February 20, 2004

Subject: USNRC Docket No. 72-1014, TAC L23657  
HI-STORM 100 Certificate of Compliance 1014  
HI-STORM License Amendment Request 1014-2, Revision 2, Supplement 2  
Supplemental Response to Request for Additional Information 2

As committed in the Reference 3 letter, we herewith provide Supplement 2 to License Amendment Request (LAR) 1014-2, Revision 2. This supplement provides the modified proposed changes to the HI-STORM CoC and FSAR required to support our responses to the second round RAI pertaining to this amendment request. In addition, as previously discussed, a small number of editorial corrections not related to the RAI are also provided for clarification. All changes submitted with this supplement are summarized in Attachment 1. The following attachments are provided. Enclosed with this letter are instructions for updating the documents in the LAR notebook.

FIGURE 2.C.1: SUPPLEMENTAL COOLING SYSTEM EXAMPLE P&I DIAGRAM

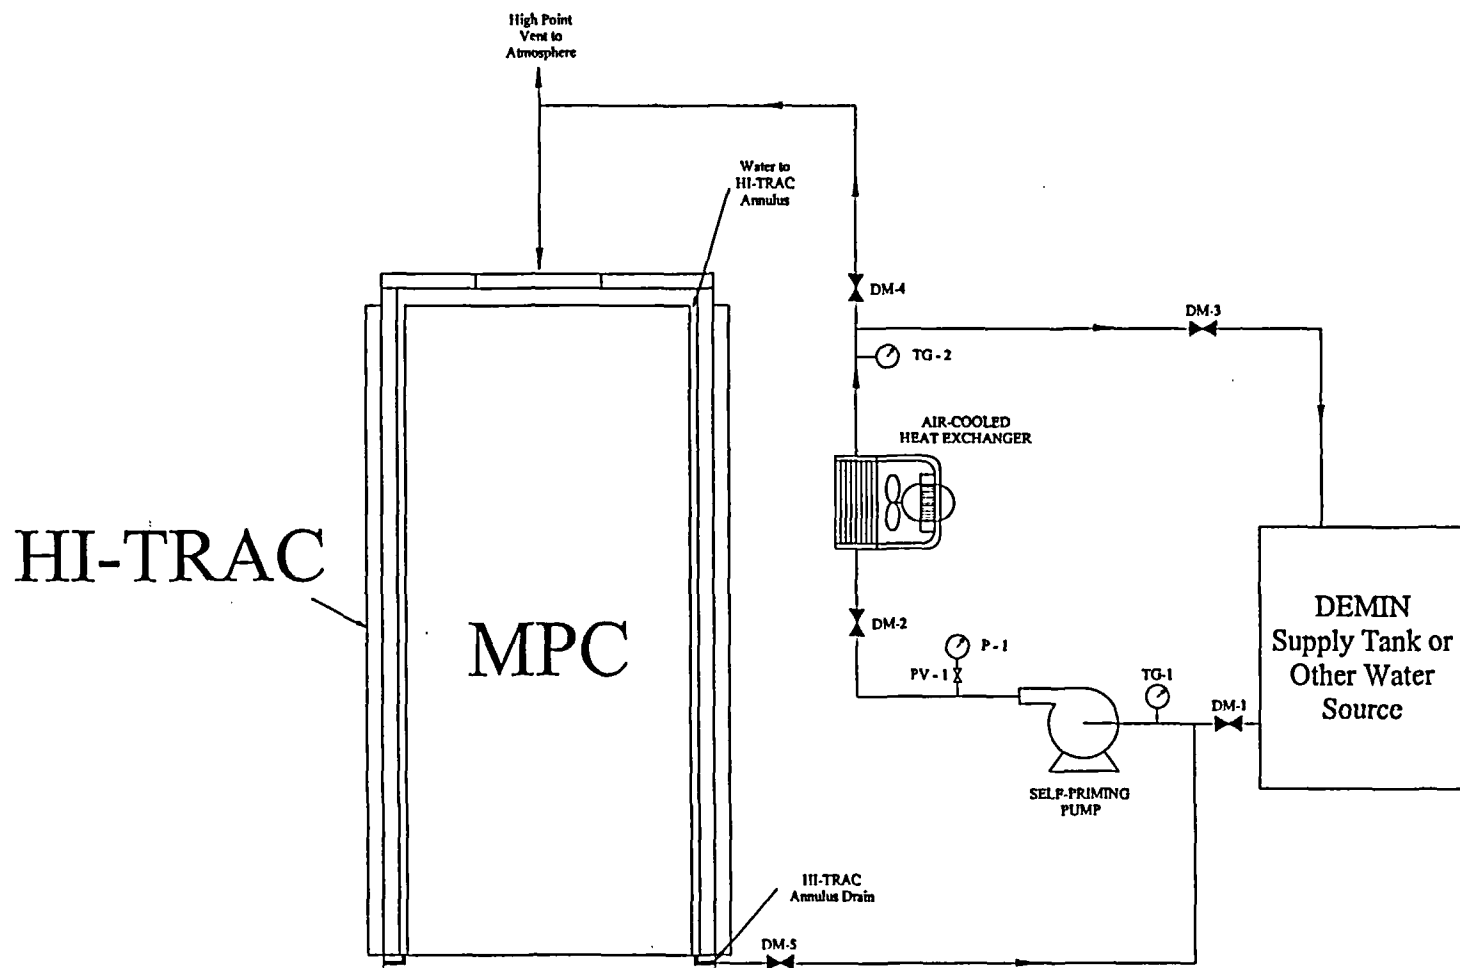
23. Remove FSAR pages 2.6-1 through 2.6-3, Proposed Rev. 2B and replace with enclosed FSAR pages 2.6-1 through 2.6-3, Proposed Rev. 2C.
24. Insert new Appendix 2.C, (3 pages including Figure 2.C.1), Proposed Rev. 2C after existing Appendix 2.B, Proposed Rev. 2B.

- k. Continue the monitoring and moisture removal until LCO 3.1.1 is the acceptance criteria are met for MPC dryness.
- l. If required, connect the Supplemental Cooling System (SCS) to the HI-TRAC annulus (See Figure 2.C.1 for an example configuration).

17. *If required, attach the SCS to the HI-TRAC annulus and begin circulating coolant. (See Figure 2.C.1). Continue operation of the SCS until MPC cool-down and re-flooding operations have commenced.*
18. *If necessary, remove the MPC downloader from the top of HI-TRAC.*
- ~~18~~-19. Remove HI-TRAC from the top of HI-STORM.

Figure 11.2.8: Peak Cladding Temperature In a Horizontal HI-TRAC

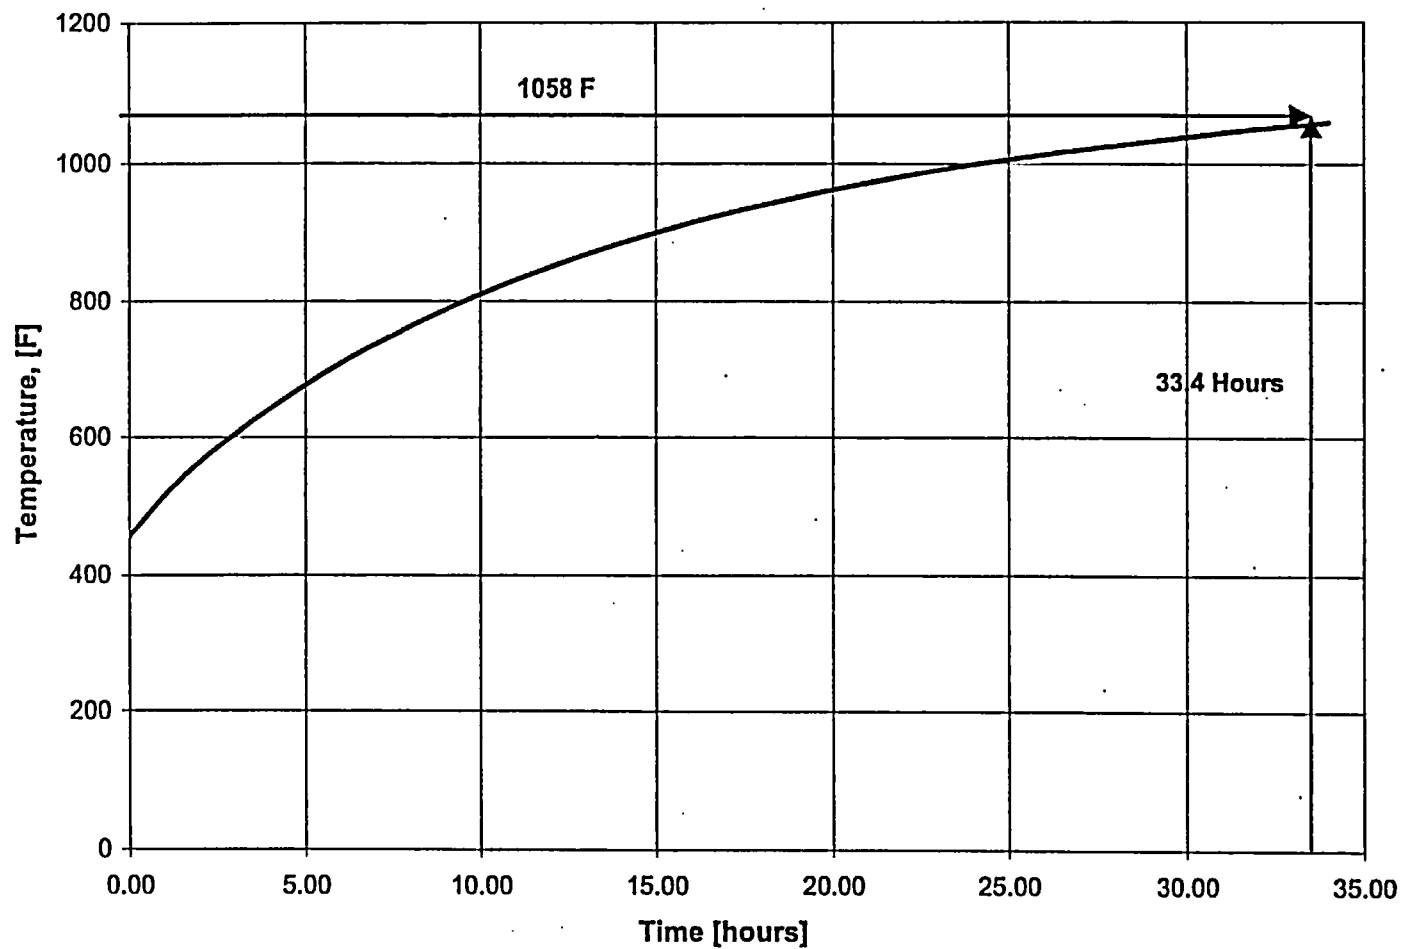
39. Insert new Figure 11.2.8 at the end of Chapter 11.
  40. Remove FSAR pages 12.1-1 through 12.1-3, Proposed Rev. 2B and replace with enclosed FSAR pages 12.1-1 through 12.1-3, Proposed Rev. 2C.
